PARTS & SERVICE NEWS

REF NO.	AT03219
DATE	Nov. 14, 2003
(C) Page 1 of 2

SUBJECT: REPAIR PROCEDURE OF RADIATOR FAN GUARD ON HM300-1

APPLICATION: HM300-1 Articulated Dump Trucks, Serial Nos.1001 and up
HM300TN-1 Articulated Dump Trucks

Fig. 1

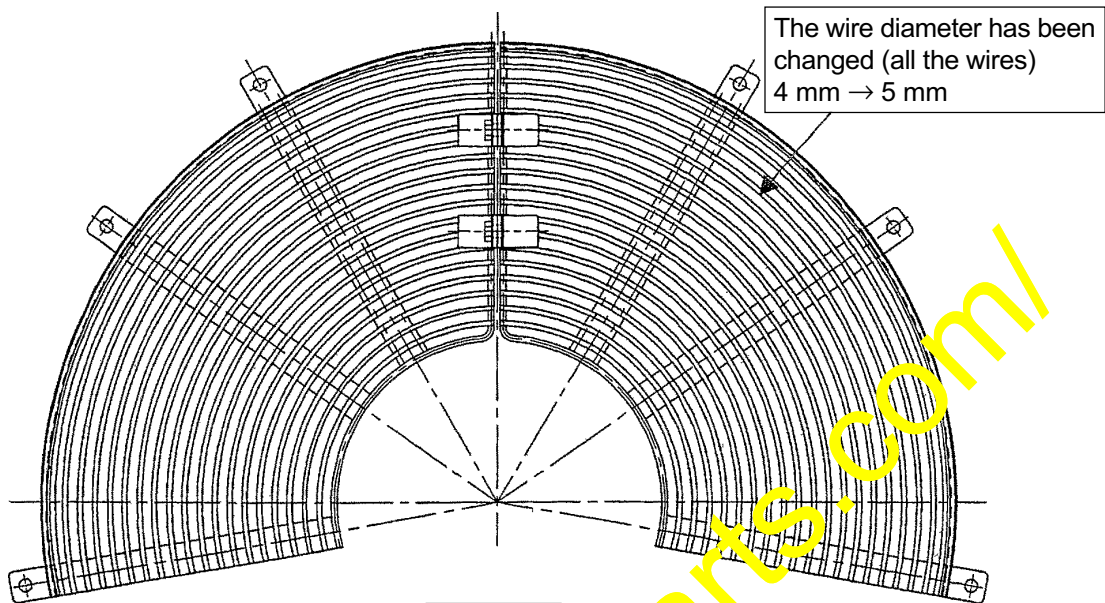
To prevent occurrence of the breakage failure of the fan guard by resonance, the diameter of the wire constituting the fan guard has been increased from 4 mm to 5 mm to increase the rigidity.

Fig. 2

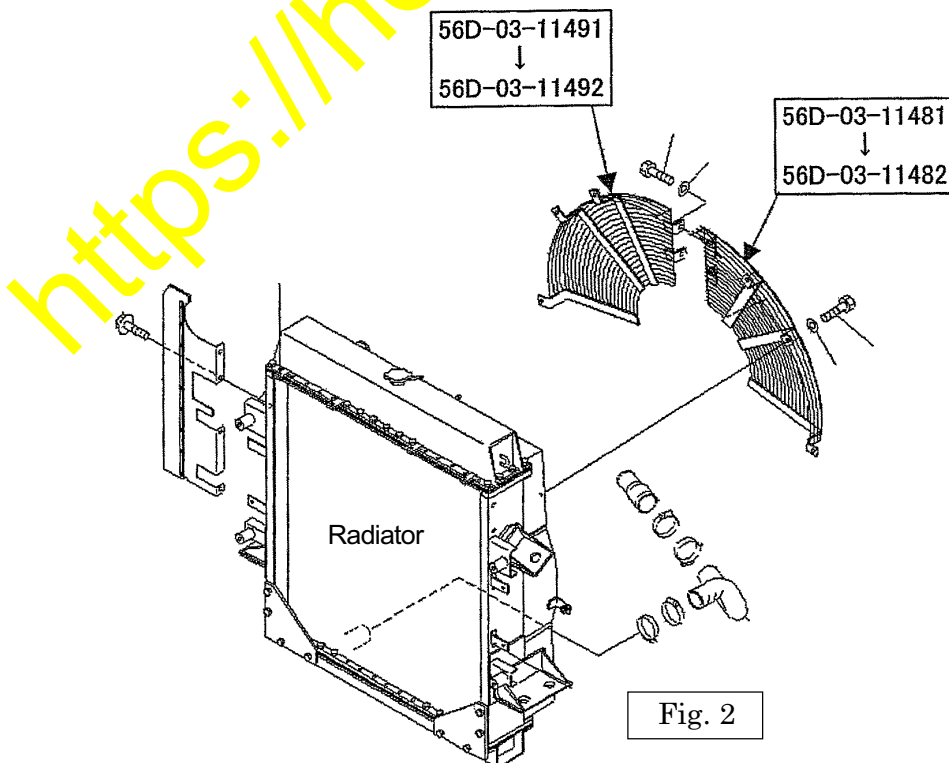
4-2. Open the engine hood and remove the LH and RH side fan guards.

(Refer to Fig. 2.)

4-3. Install the strengthened fan guards (56D-03-11482, 56D-03-11492).

(Refer to Fig. 2.)
